DEPARTMENT OF ENVIRONMENTAL MANAGEMENT  
 OFFICE OF WATER RESOURCES  
 FRESHWATER WETLANDS PROGRAM  
 APPROVED WITH CONDITIONS  
 AS SPECIFIED IN THE LETTER OF APPROVAL  
 JUL 29 2014 FILE # 14-0112  
 NO CHANGES ALLOWED WITHOUT PRIOR APPROVAL  
 APPROVED PLANS MUST BE AT CONSTRUCTION SITE

PROJECT:  
 ANDREA COLOGNESE & DORIANA CARELLA  
 PROPOSED RESIDENCE TO BE LOCATED  
 AT 85 GONDOLA AVE., JAMESTOWN, RI  
 ASSESSOR'S PLAT 16, LOT 351

DRAWING TITLE:  
 PROPOSED CONDITIONS SITE PLAN

DRAWING NO:  
 S-1

**OVERALL PLAN**  
 SCALE: 1" = 20'

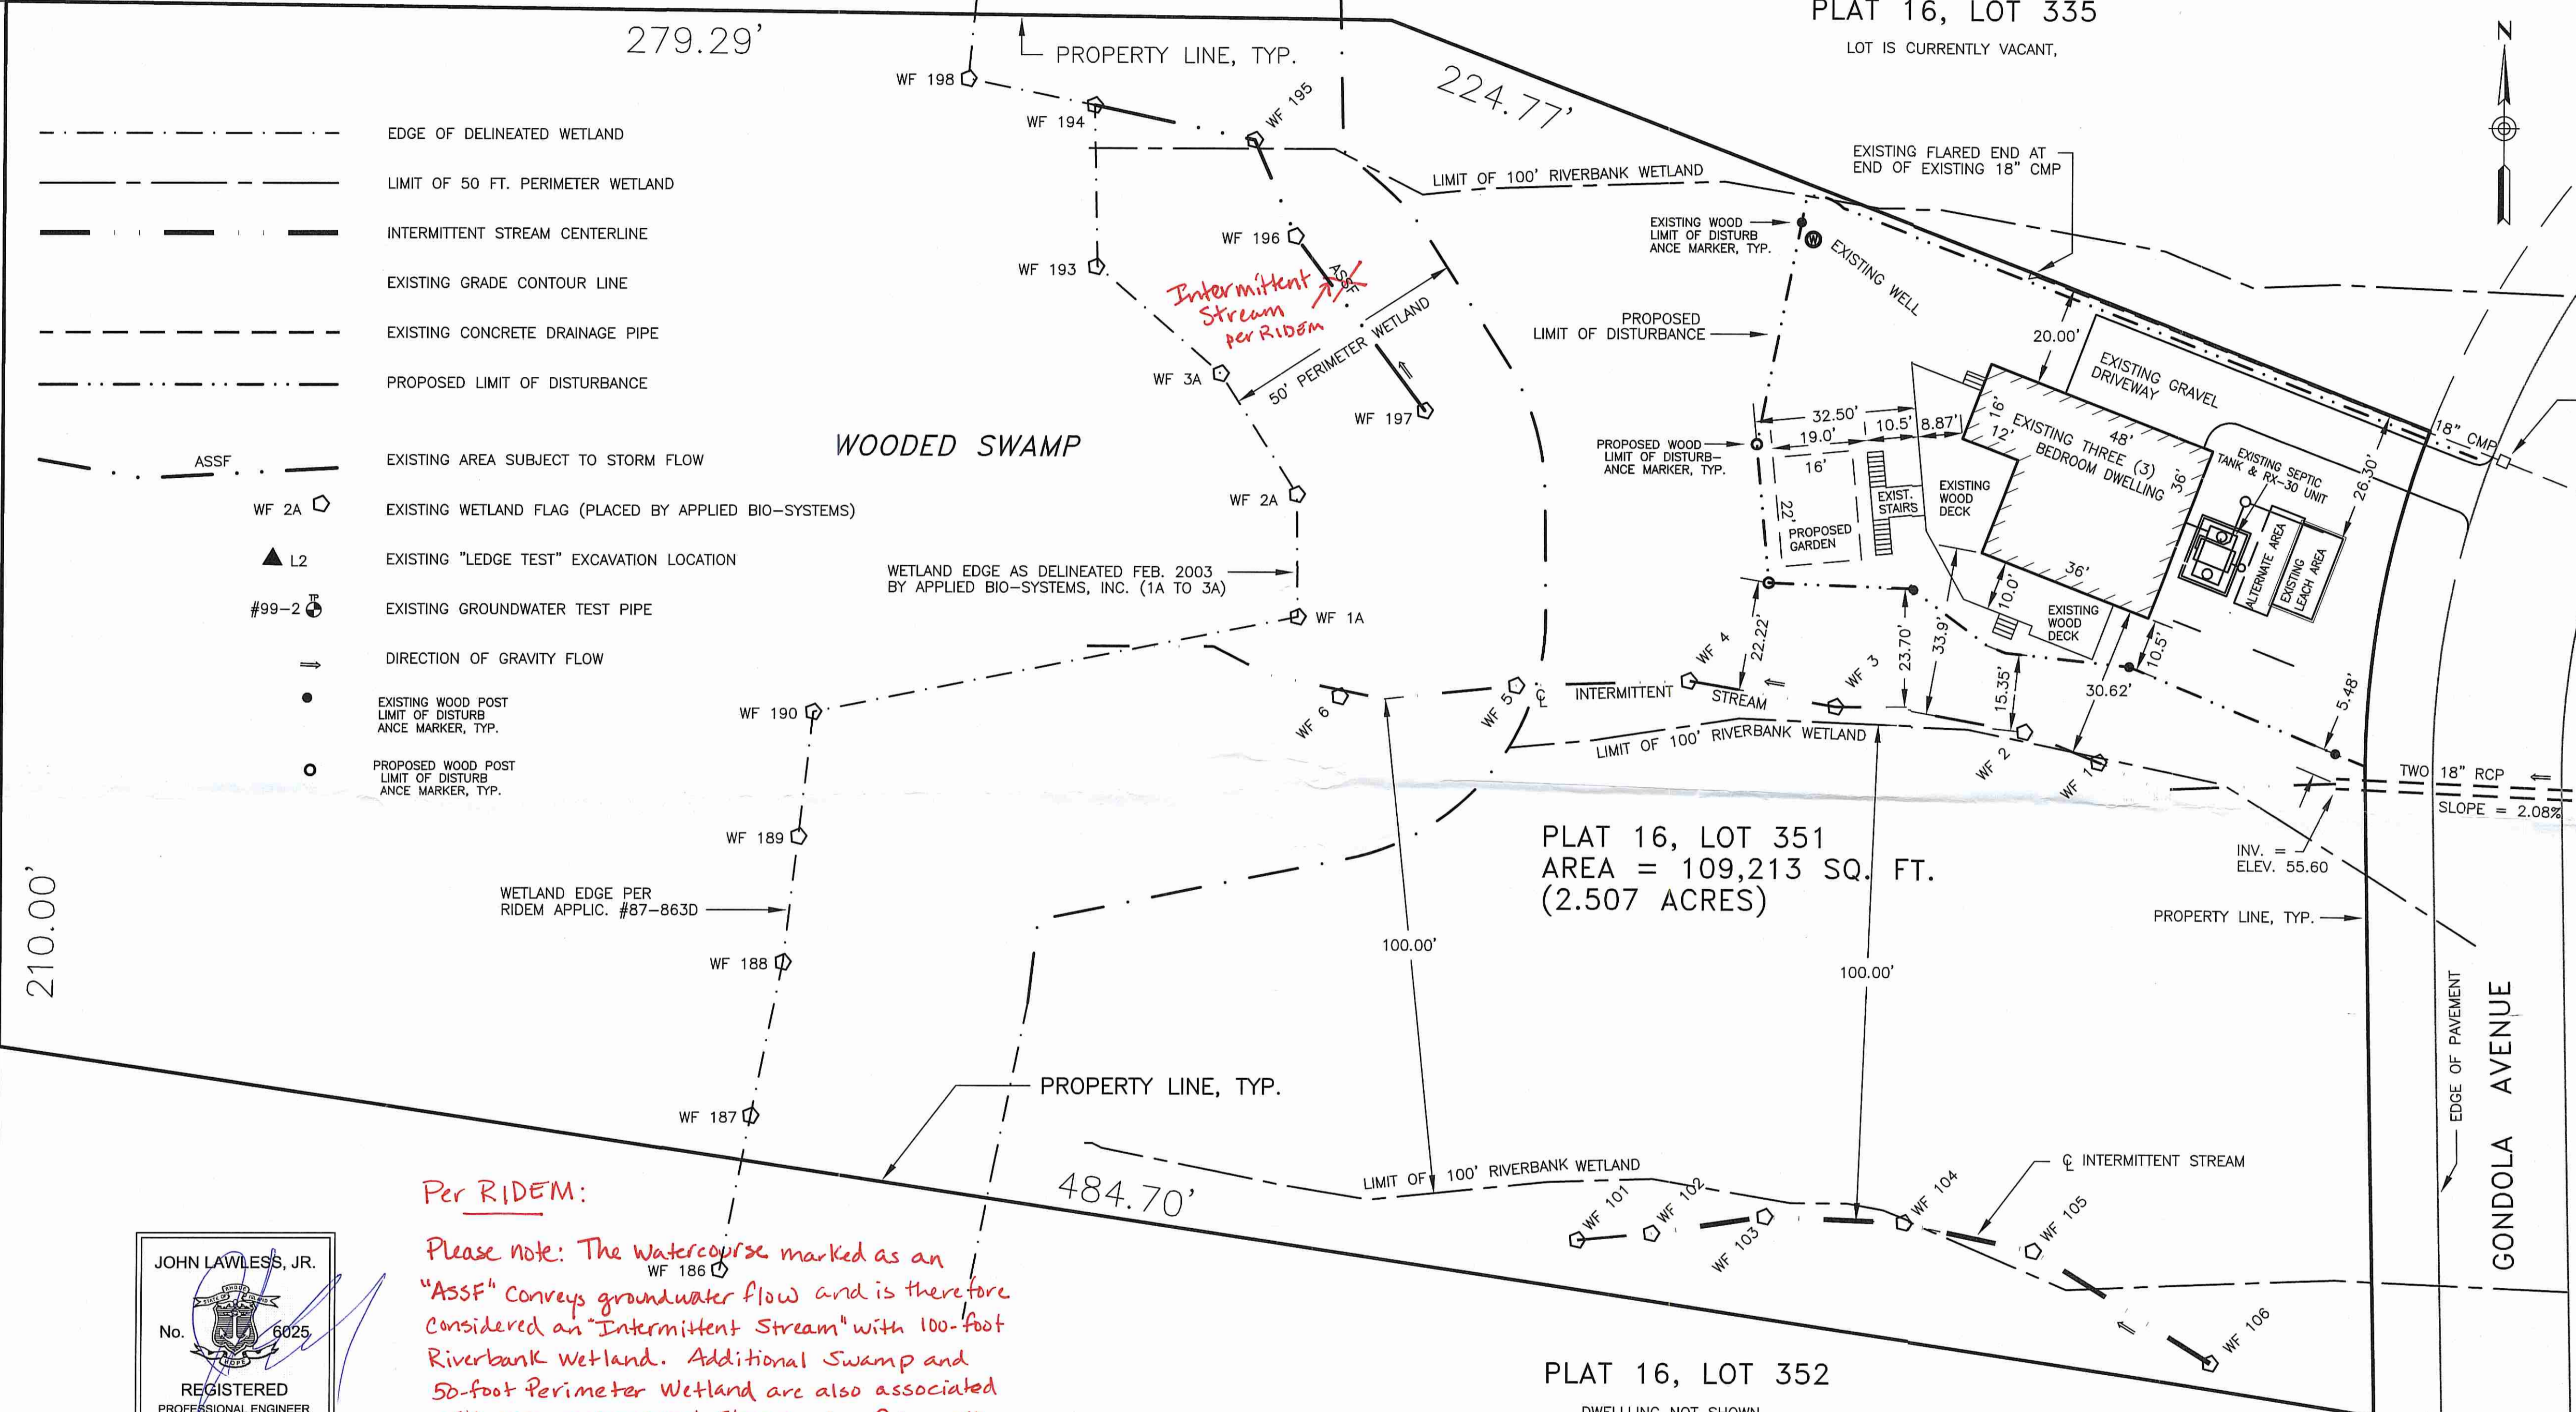
Kindly be advised that this Permit is not sufficient to a verification of the type or extent of freshwater wetlands on site.

**Per RIDEM:**  
 Please note: The watercourse marked as an "ASSF" conveys groundwater flow and is therefore considered an "Intermittent Stream" with 100-foot Riverbank Wetland. Additional Swamp and 50-foot Perimeter Wetland are also associated with this Intermittent Stream. Any future site plans must clearly depict these wetland resources.
